**THROTTLE AND BRAKE LEVER SUPPORT
1973 AND LATER X-90, Z-90, SX TX-125**

HARLEY-DAVIDSON MOTOR CO., INC.

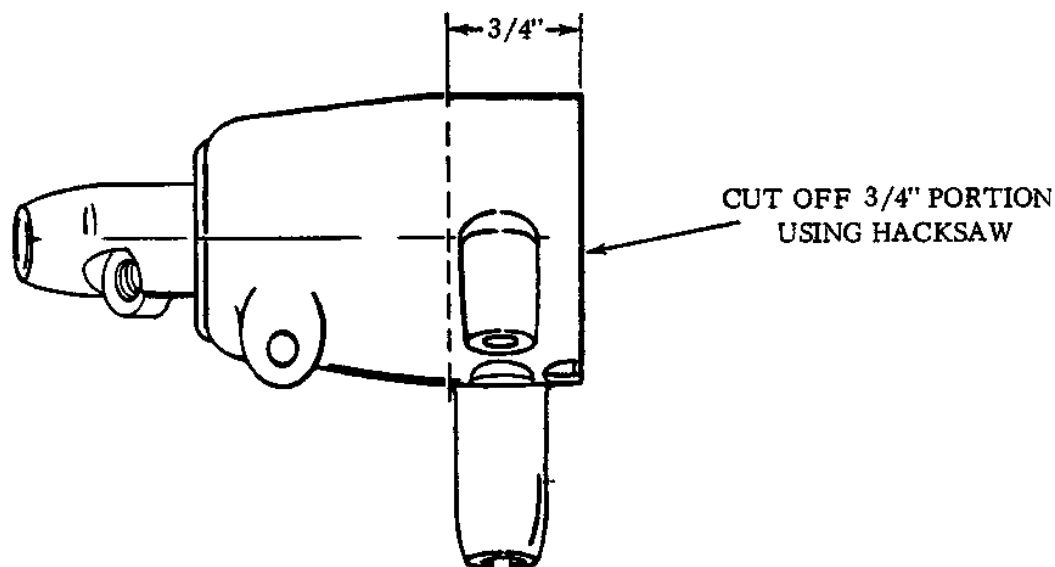
The right handlebar brake lever support, part No. 45025-73PA, used on 1973 and later X-90, Z-90, SX/TX-125 models includes a boss which retains the throttle cable elbow. Breakage of the boss frequently occurs as a result of the lever effect which the elbow exerts on the support when a heavy force is applied to the elbow.

Remove the broken lever support. Saw off the throttle portion with a hacksaw as shown by the dotted line in the illustration.

In the past it was necessary to replace the complete support assembly. Now it is possible to reuse the throttle and brake lever support by sawing off the throttle portion and fitting a separate throttle grip assembly, part No. 45186-74P, to the lever support. A similar assembly is used on later model motorcycles.

Install modified brake lever support on the handlebar and fit throttle grip assembly, part No. 45186-74P, snug against the support.
